JANUARY 16, 2024 | REGULAR MEETING

Town of Stonington  
Planning and Zoning Commission

Town of Stonington | Department of Planning  
Planning and Zoning Commission Meeting  
January 16, 2024  
Summary of Administrative Review Items<sup>1</sup>

SHEET 1 OF 4

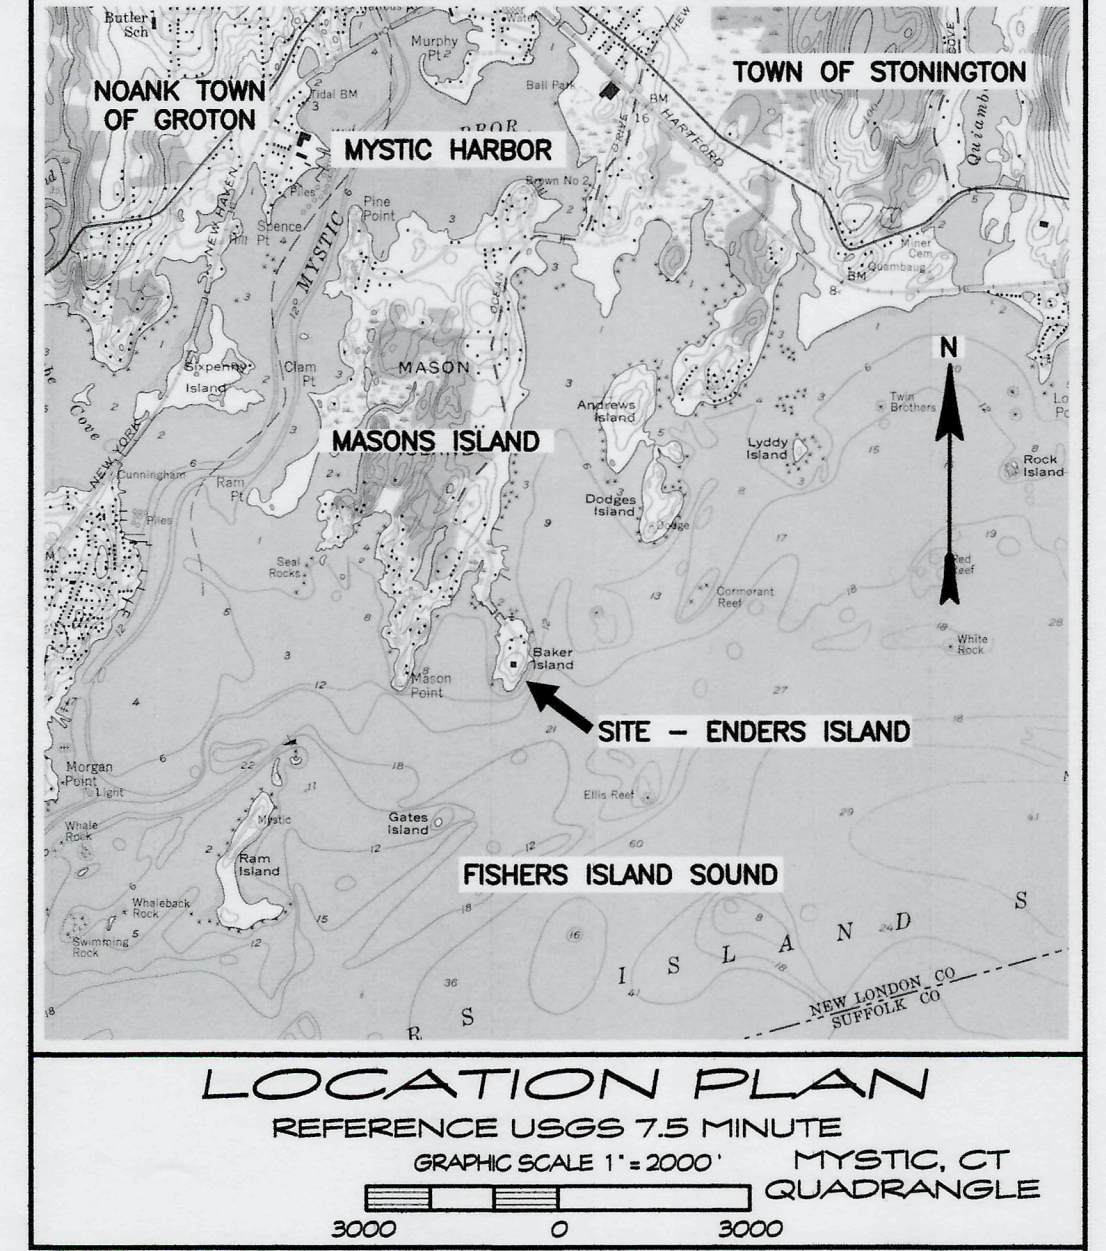
1. The bulk requirements for the RC-120 Zone are incorrectly labeled on Sheet 1.
2. The applicant should include a detail showing the proposed walkway material and rail design. Additionally, the applicant should show available and proposed ADA-accessible ramps or pathways on the Site Plan.
3. The Landscape Plan (Sheet 4) does not show the proposed landscaping for areas where there is existing *Boulder Rock Stockpile and Brush* (Sheet 2). The applicant should revise the Landscape Plan to include the entirety of the island.
4. This application received an overwhelming number of comments from the public. As of the date of this report, there are 119 comments in favor of the application, and 3 opposed.

C-3

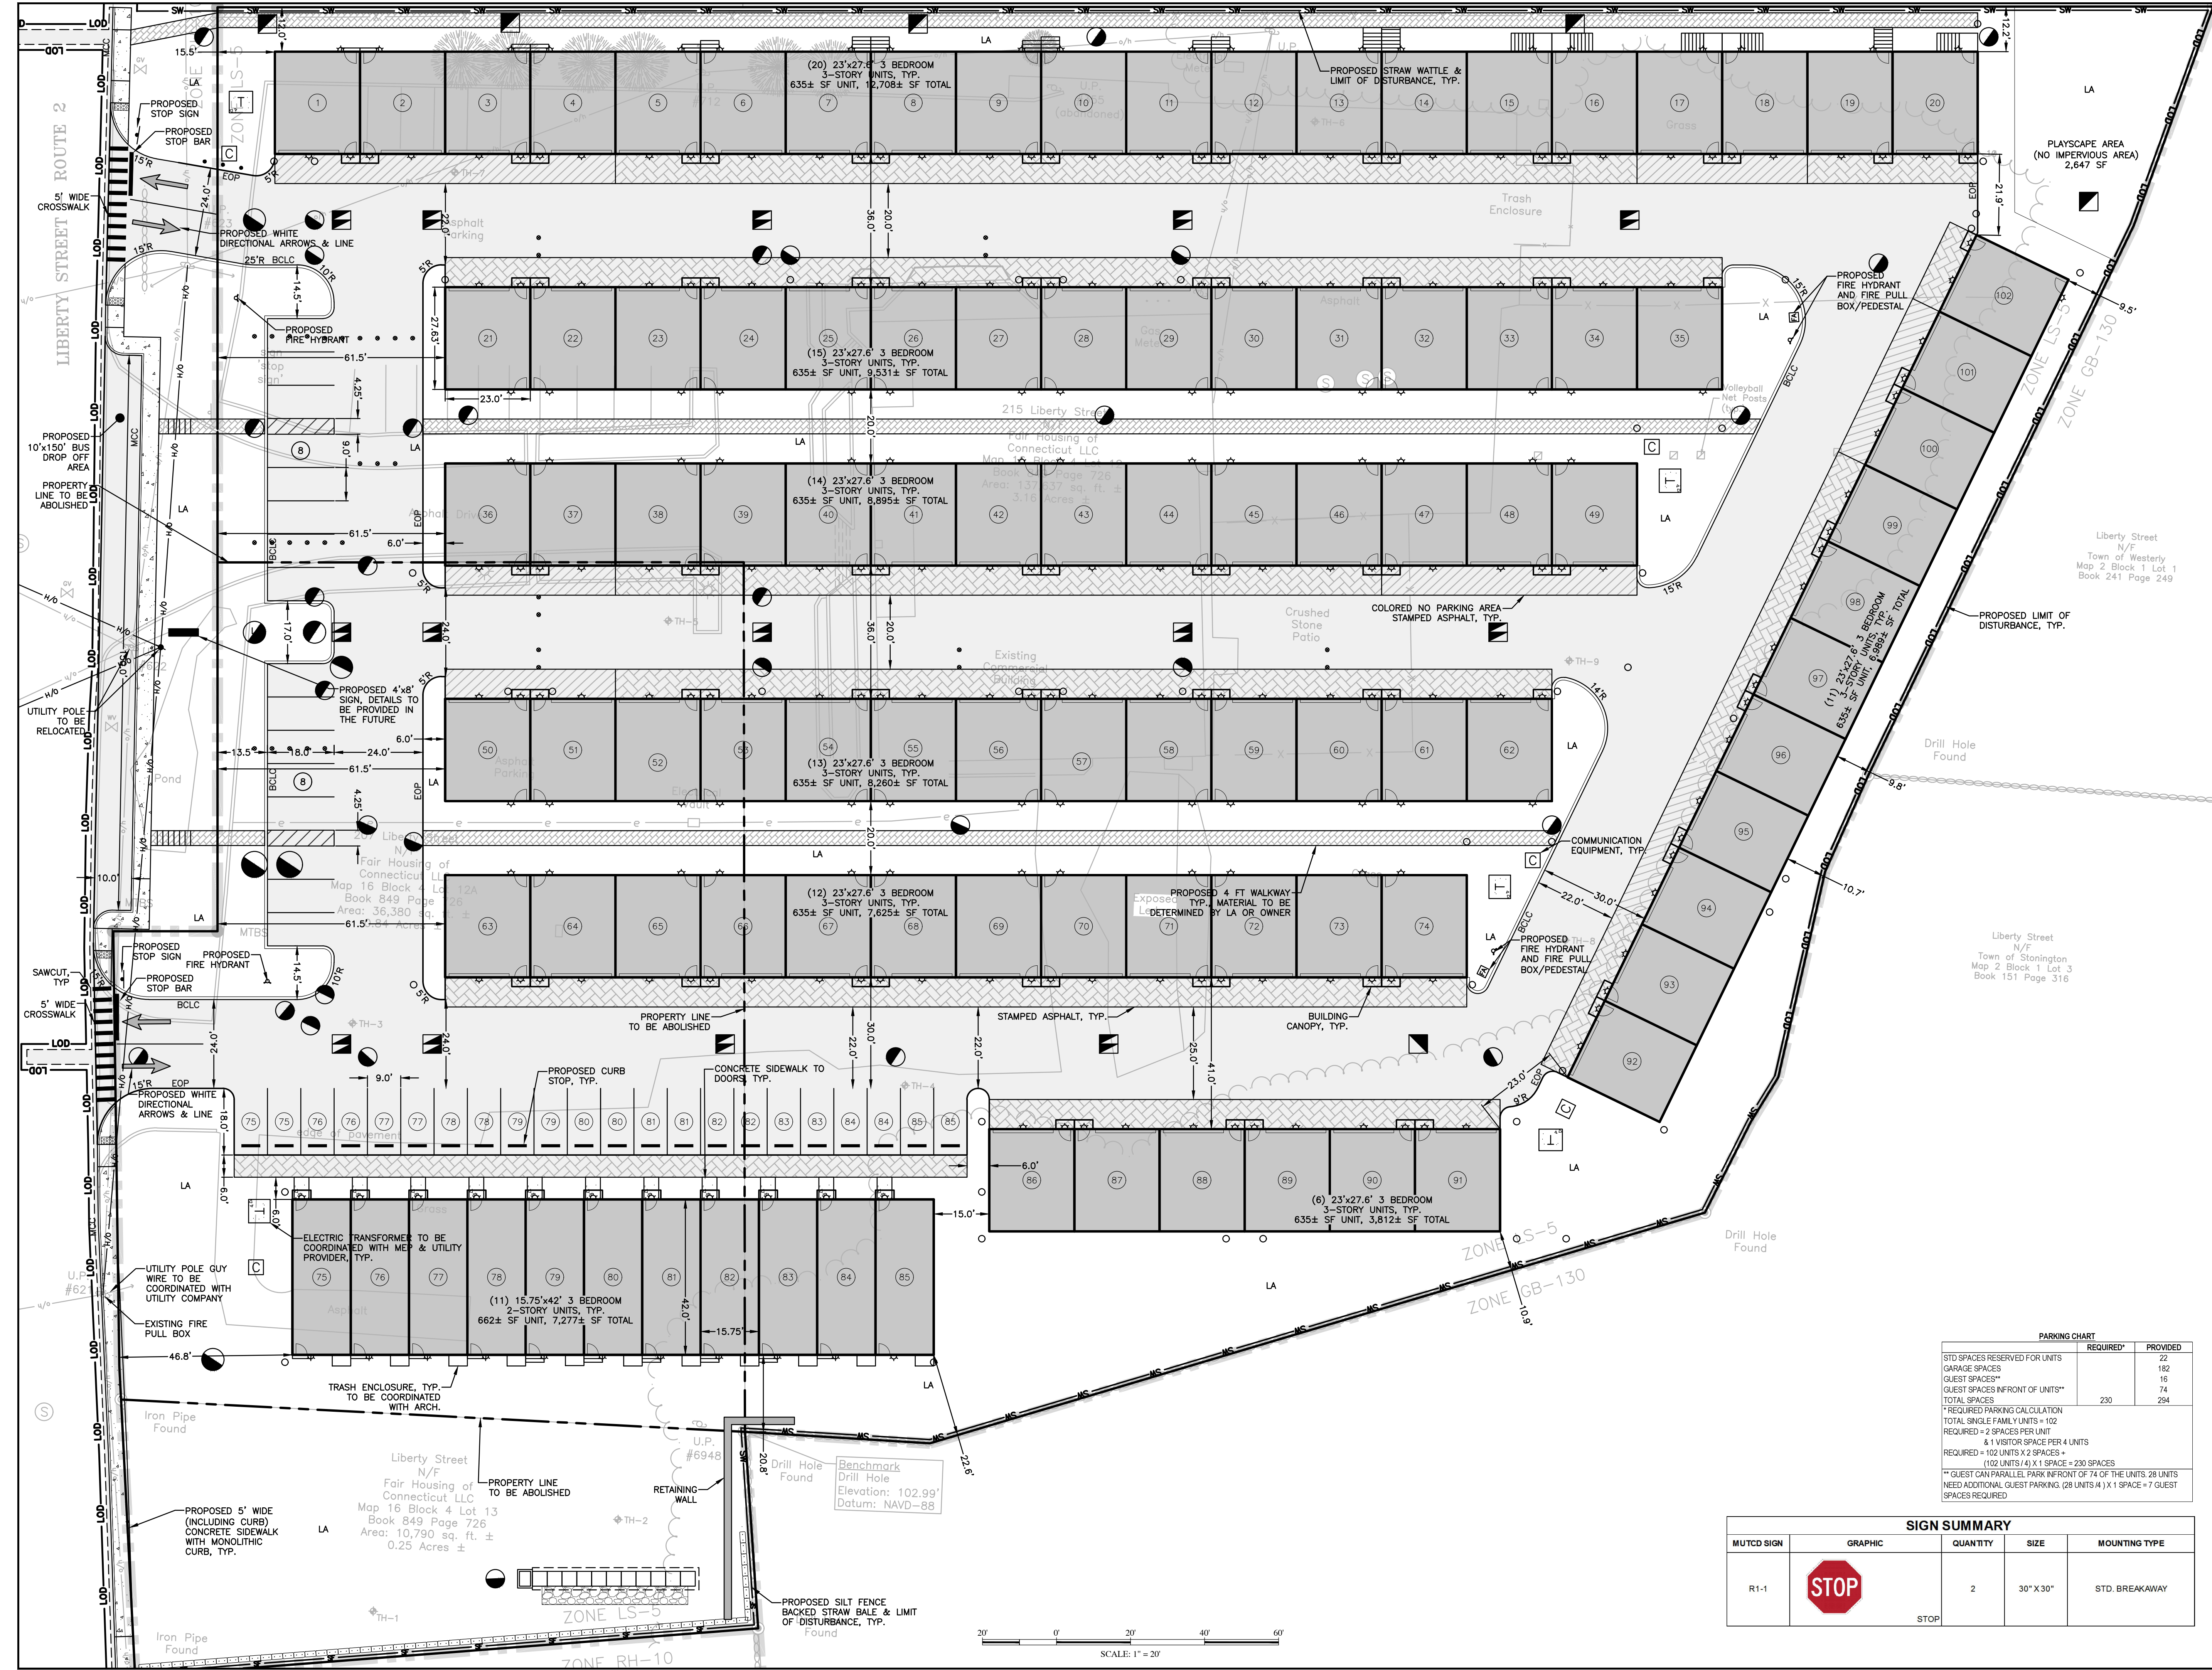
- 3. The Fire Truck Autoturn Sketch (FIG-1) shows the radius required for precise turning of the fire apparatus on the site. The plan shows that 20 of 113 dwelling units are prohibited from using the third parallel parking space to accommodate emergency vehicle turning. The applicant should clarify whether or not residents are allowed to use that parking space and whether or not those spaces were removed from the overall parking calculation.*

1. *The allocated snow storage area (Sheet C-3) remains inadequate, therefore additional area and/or a snow removal plan should be incorporated for the site. DPW has indicated they will not participate in snow plowing and/or removal for the site.*

Response to Comment: The parking chart on sheet C-3 states how many parallel guest parking spaces are accounted for in front of units. This table also demonstrates that sufficient guest parking is provided on the west side of the project for the units that cannot be parked in front of (17 units) and the units without garages (11 units) at a rate of 1 guest spot per 4 units based on the zoning code. The plan identifies where the no parking areas are which will be a colored or painted stamped asphalt different from other stamped areas.
